Subject: East Altamont Energy Center Application for Certification
Data Request Response Set #1 (01-AFC-04)

East Altamont Energy Center
Data Requests and Responses (01-AFC-4)
Set #1

EAST ALTAMONT ENERGY CENTER DATA REQUEST AND RESPONSE SET #1 (01-AFC-4)

Technical Area: Visual Resources

Figure 6.3c

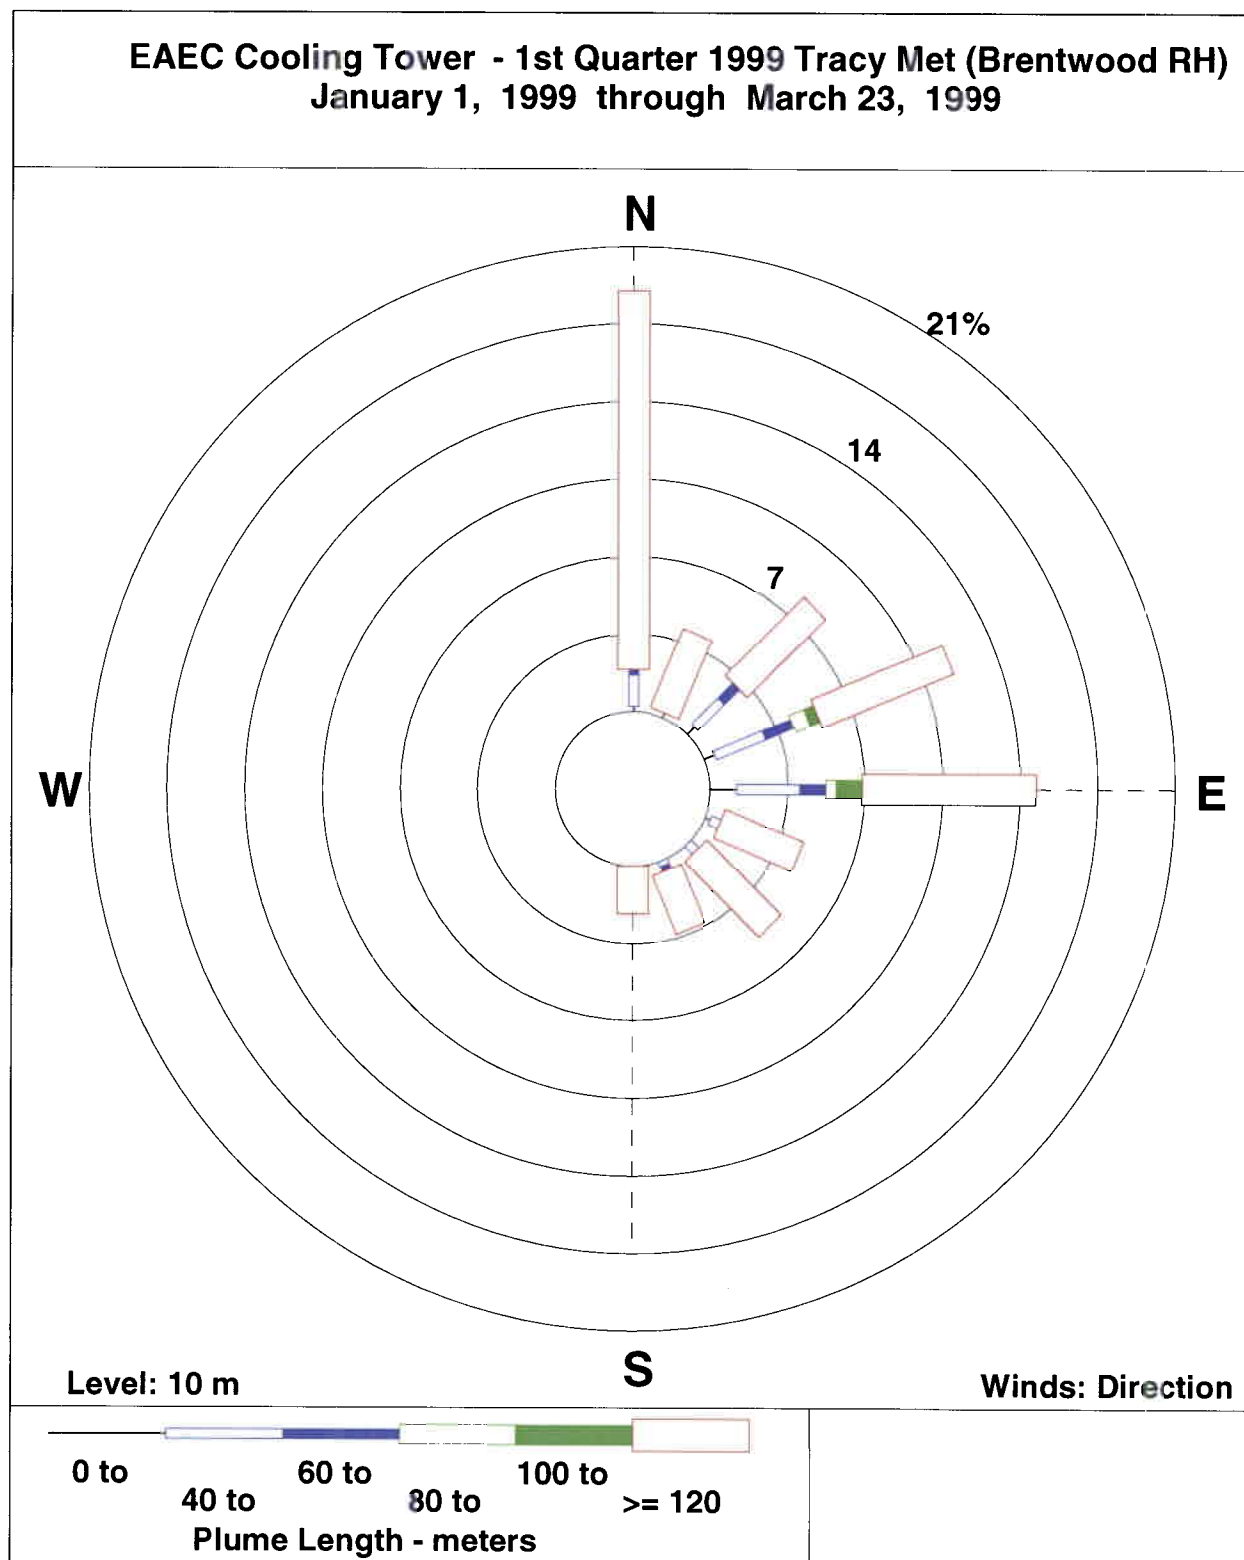
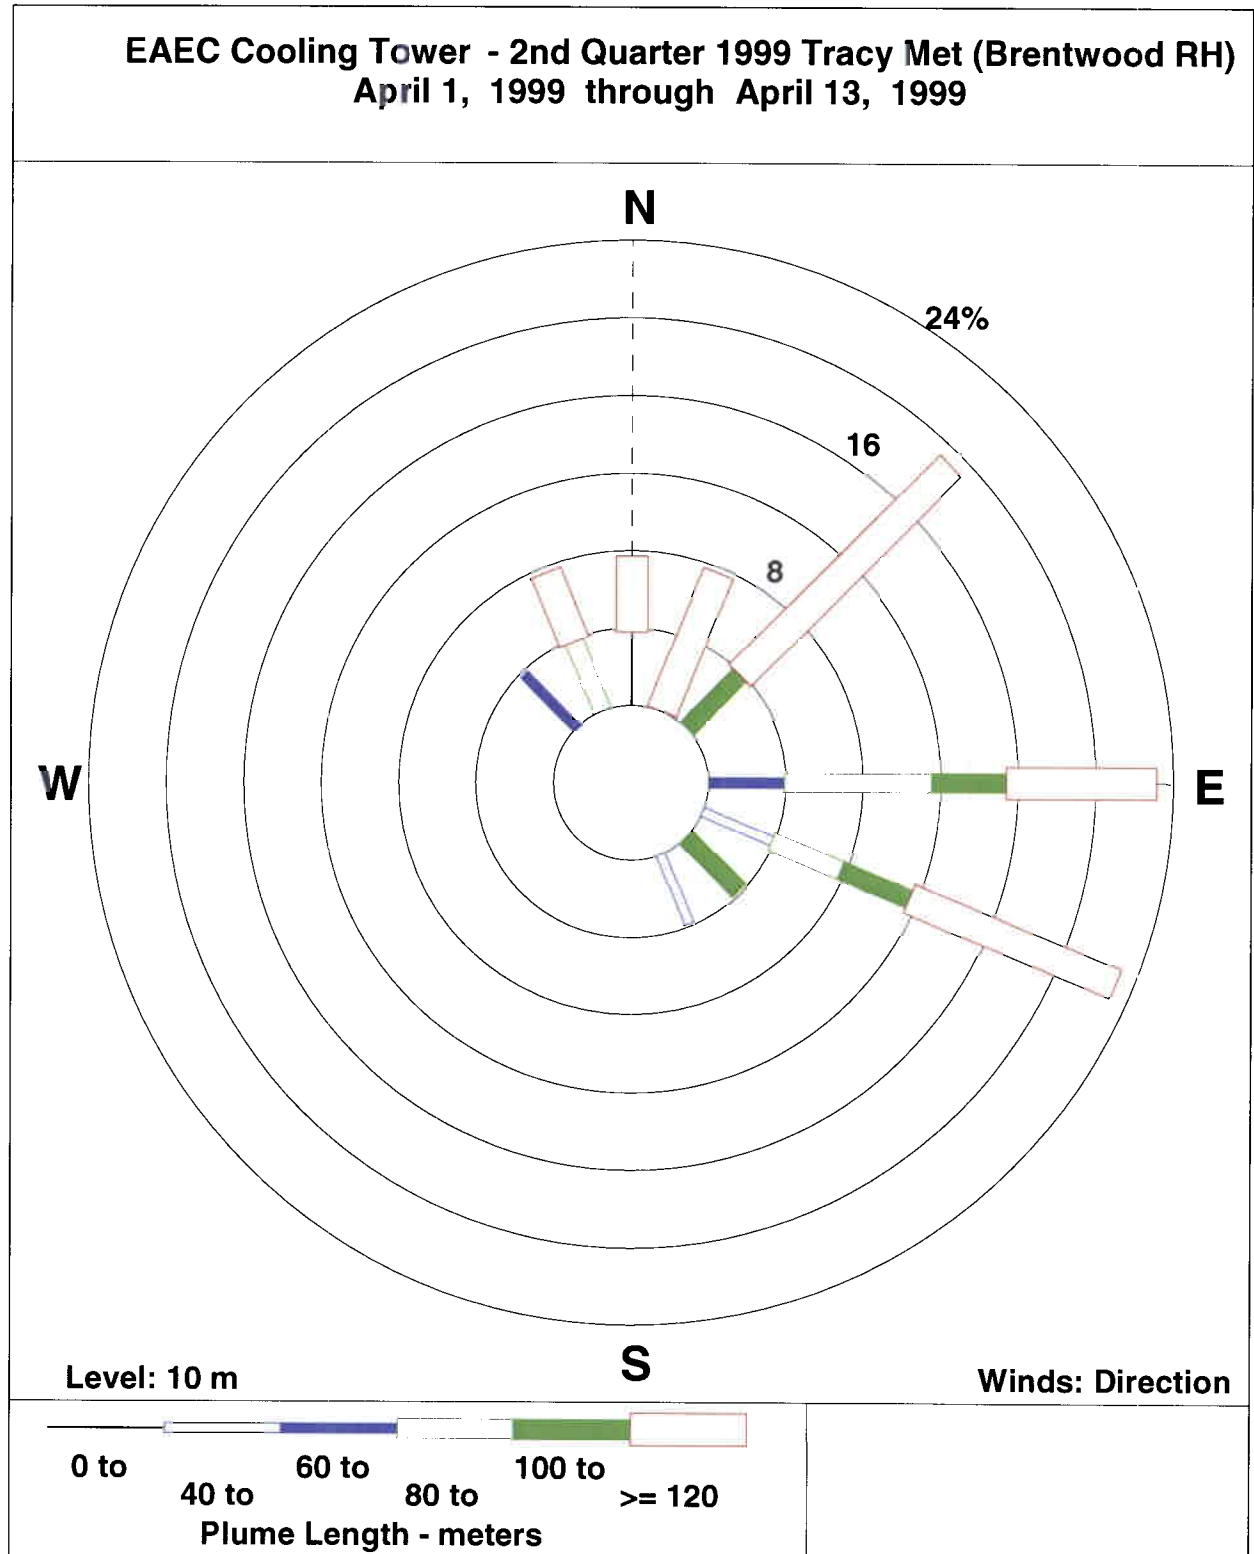
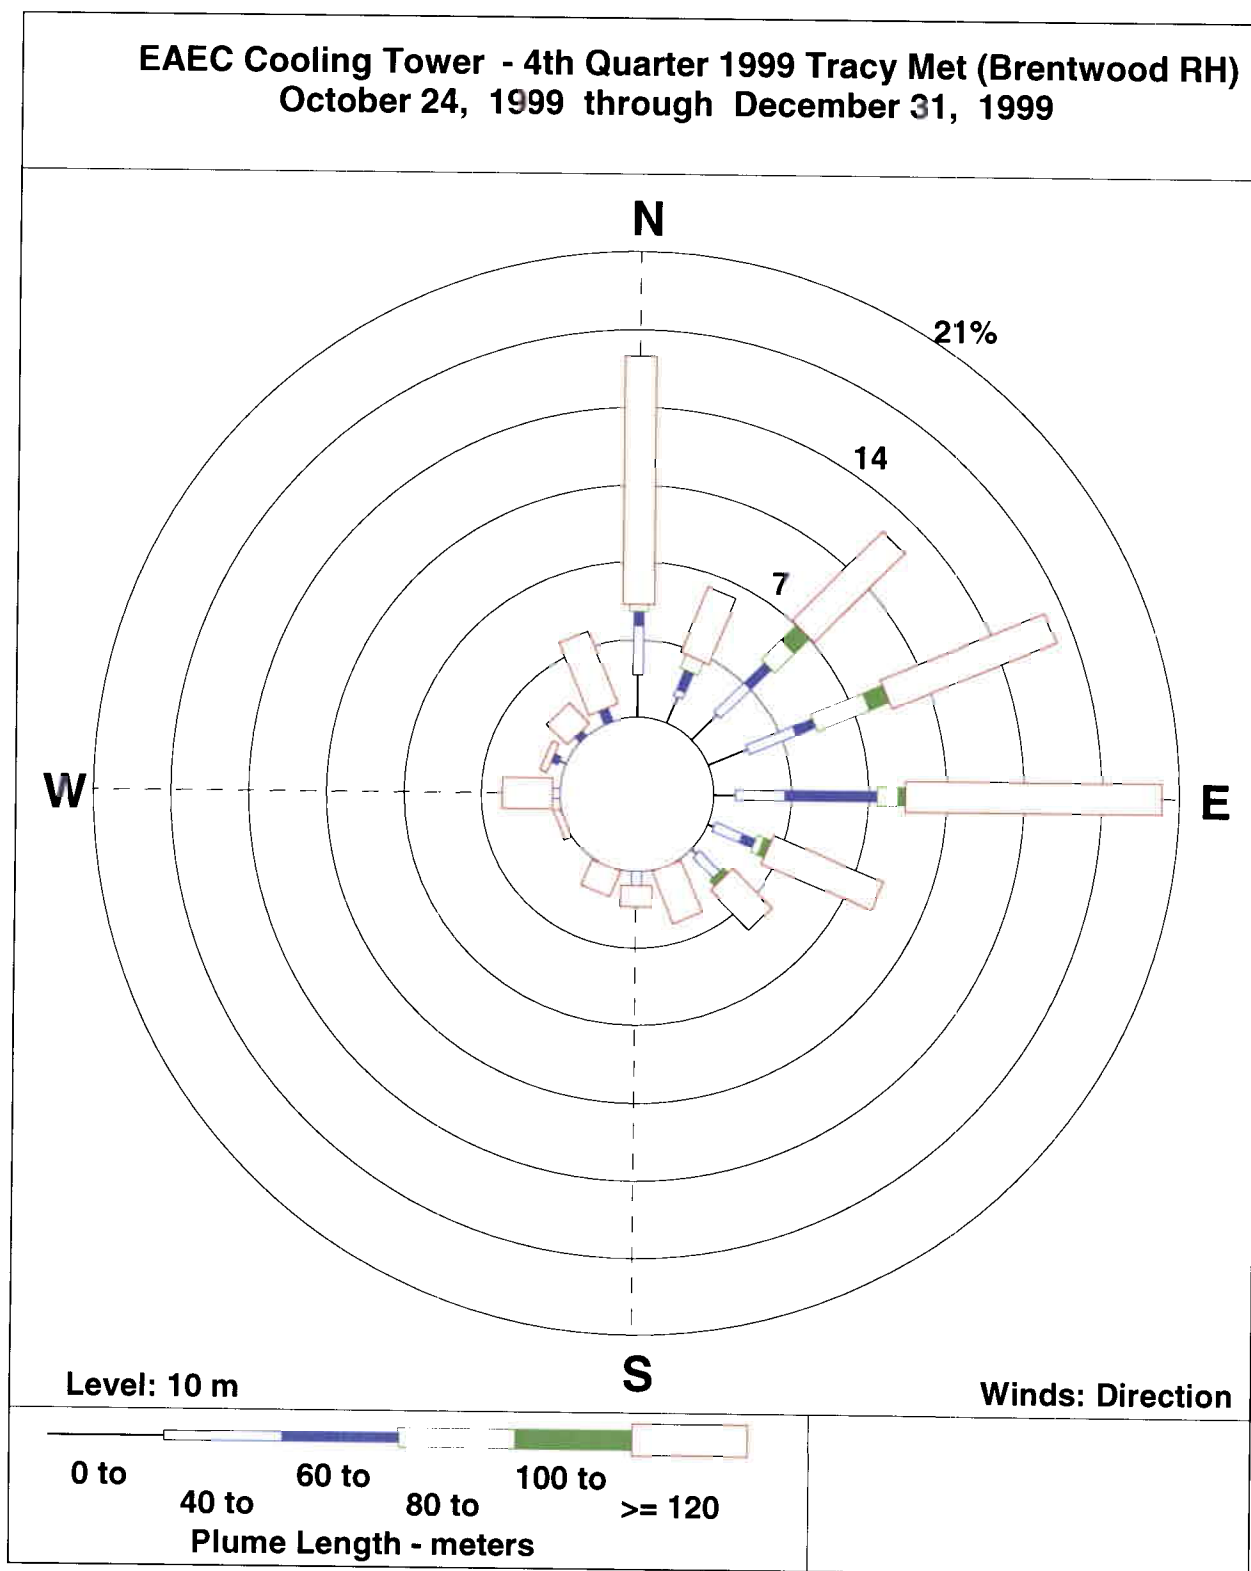
- a. The total number of daylight hours annually and seasonally;

Response: Table VIS-6.1 shows the number of hours per year that there is the potential for formation of a visible water vapor plume of various lengths from each cooling tower cell. The analysis assumes that each cooling tower cell is operated for 8,760 hours per year. The analysis was performed for each of the three years of meteorological data available.

A seasonal distribution of these hours is presented in the plume roses included as Figures VIS-6.1a through VIS-6.1l.
